SHADYBROOK COMMERCIAL COMMUNITY UNIT PLAN

DP-210
APPROVED CUP
11-93 DM
BCC 3-9-93 DM

RE: CUP2025-00030 – Administrative Adjustment in the City to the Shadybrook Commercial CUP DP-210 to permit one freestanding sign to face parallel to the adjacent street and modify sign base construction materials, on property zoned LC Limited Commercial District; generally located on the south side of East 21st Street North and within one-block west of North Hillside Avenue (3051 E. 21st Street North).

RE: CUP2015-25– City CUP Administrative Adjustment to DP-210 of the Shadybrook Commercial Community Unit Plan; generally located at the southeast corner of East 21st Street and Carmen (3015 E. 21st Street North).

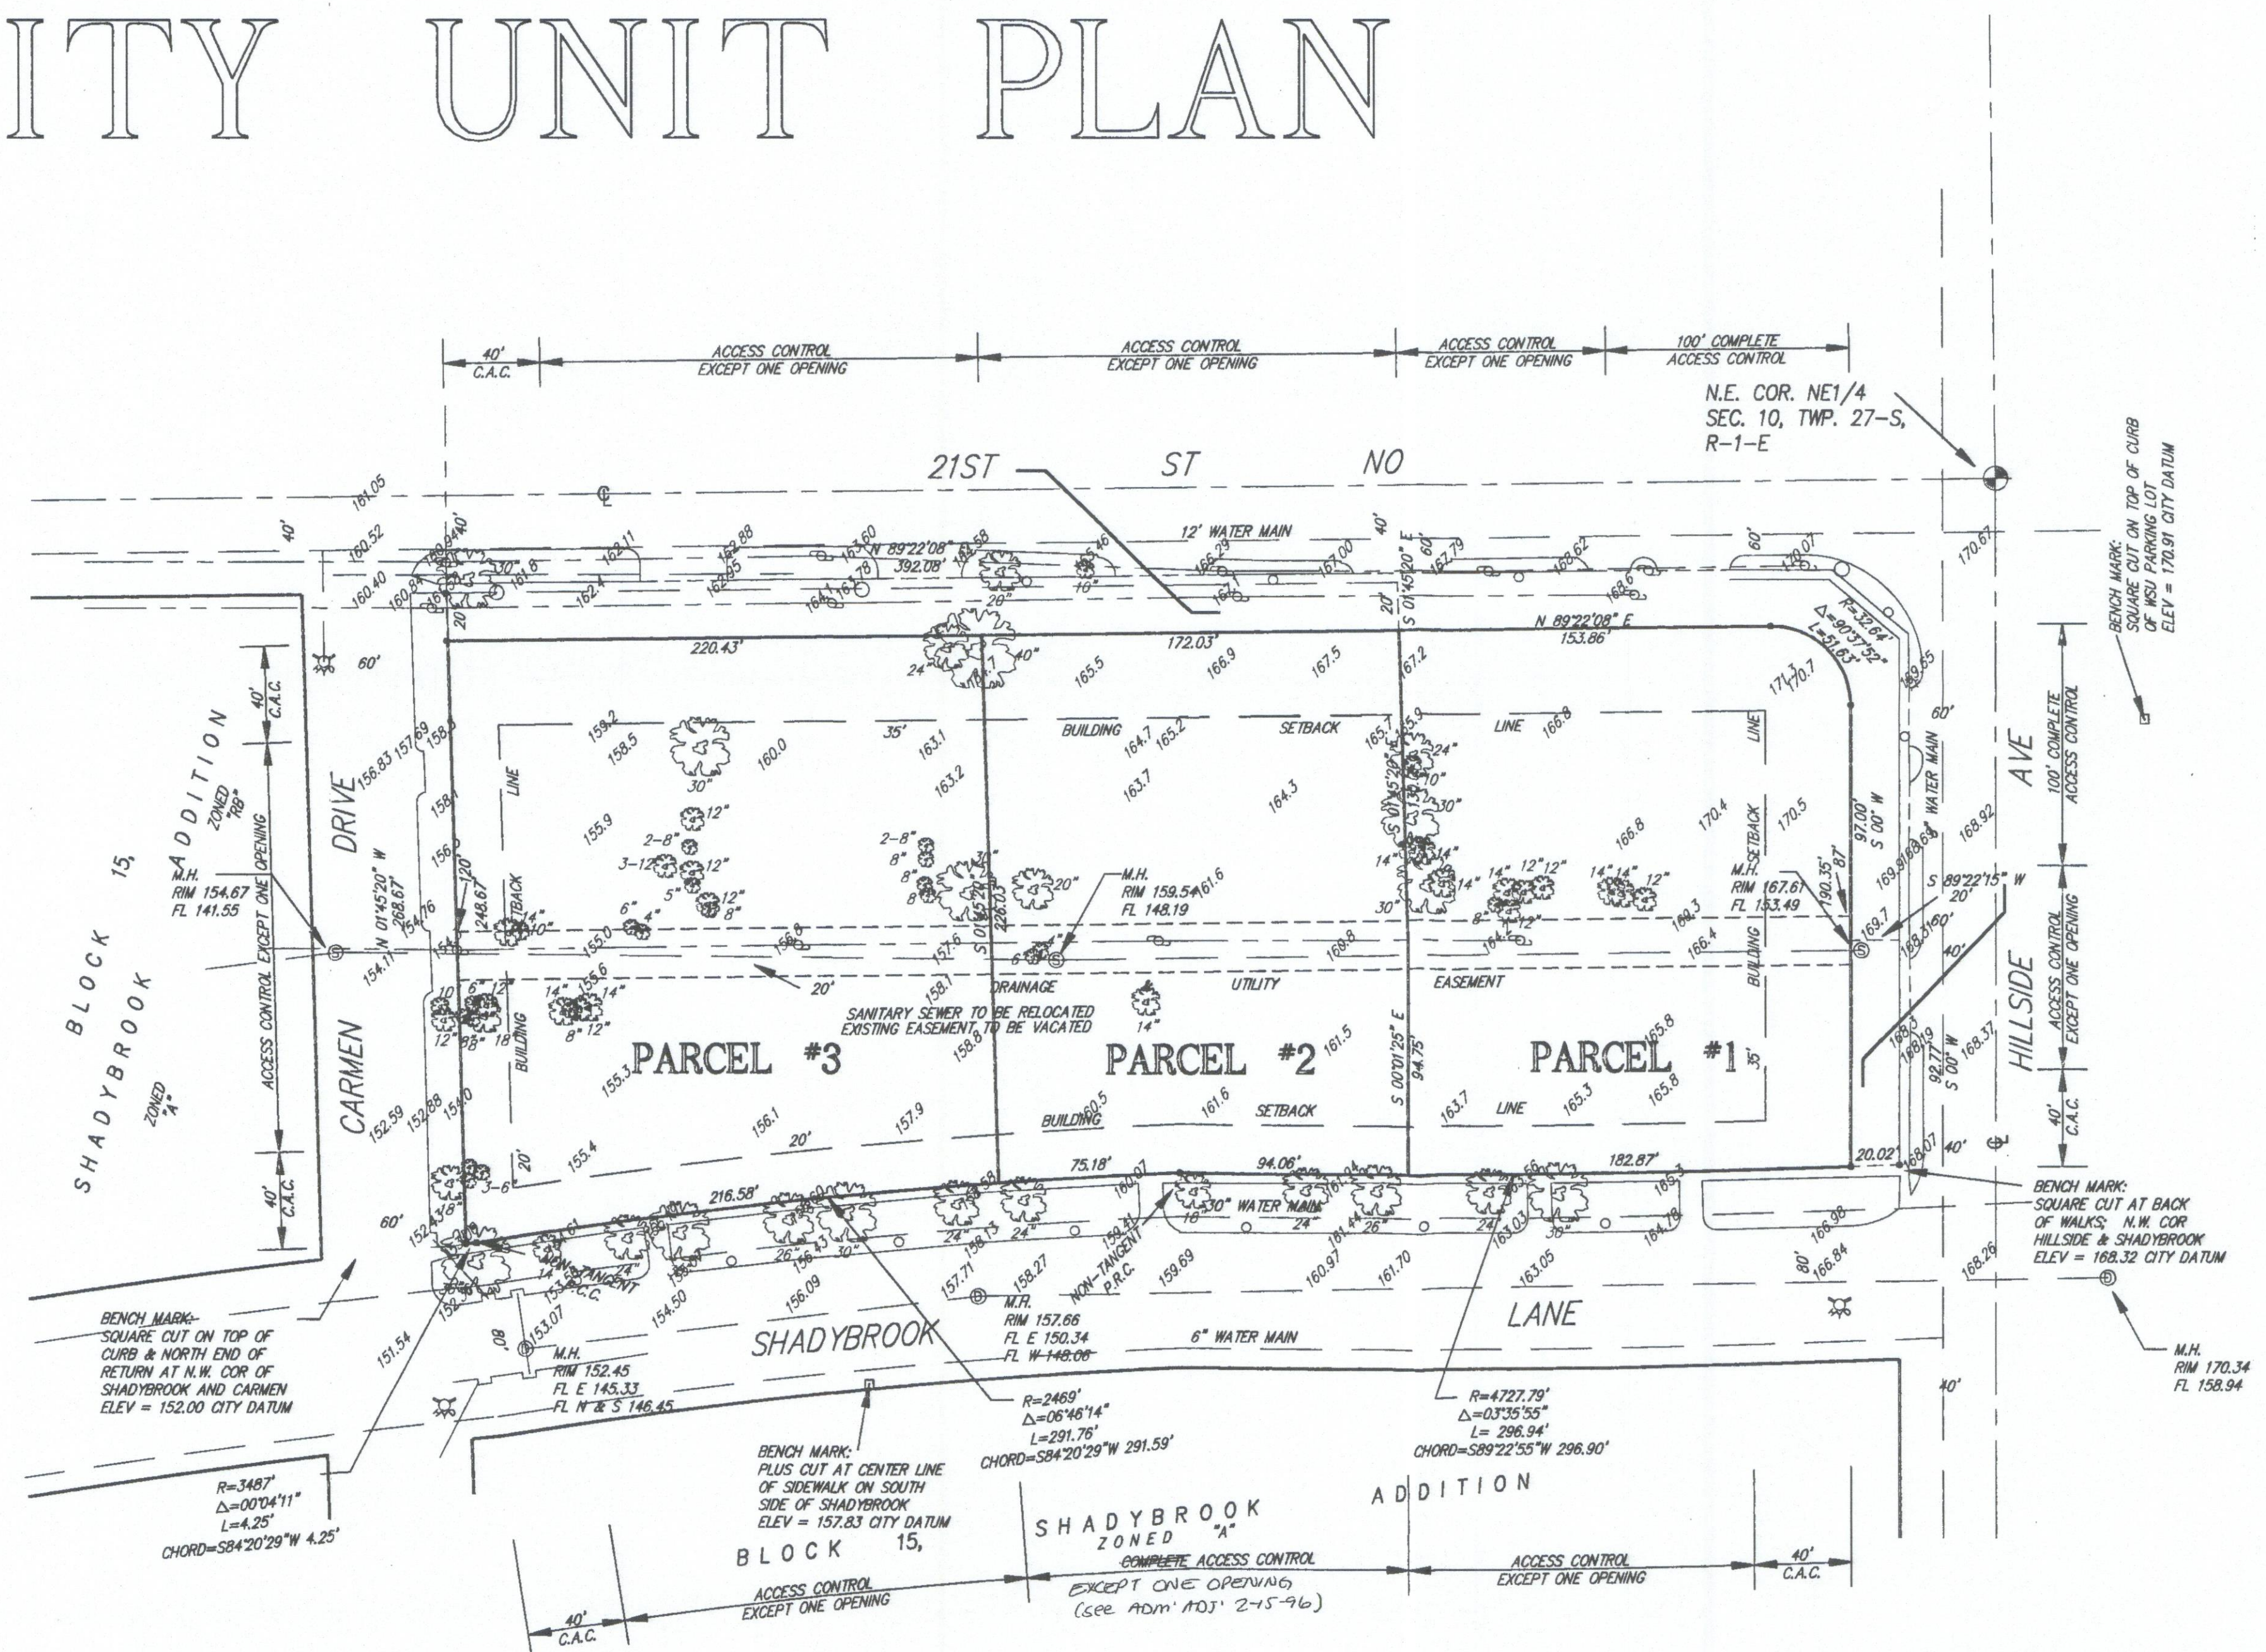
The application proposes adding stipulation "e," which would state: **"One monument sign is allowed on Parcel 2 to be parallel to the street."**

It is also proposed to modify General Provision to exclude the proposed sign on Parcel 2 from having a brick base. Below is the staff recommended modified text for General Provision 7.

- Red brick shall be used in a prominent manner in the exterior design for all parcels, e.g. on building elevations, as the base for ground signs, and/or on the face of any retaining walls. The use of cast stone trim is also encouraged. All roofs visible from the street shall be of hipped construction. The monument sign base for Parcel #2 may have a concrete base.

7. Red brick shall be used in a prominent manner in the exterior design for all parcels, e.g. on building elevations, as the base for ground signs, and/or on the face of any retaining walls. The use of cast stone trip is also encouraged. All roofs visible from the street shall be a hipped construction. **The monument sign base for Parcel #2 may have a concrete base.**
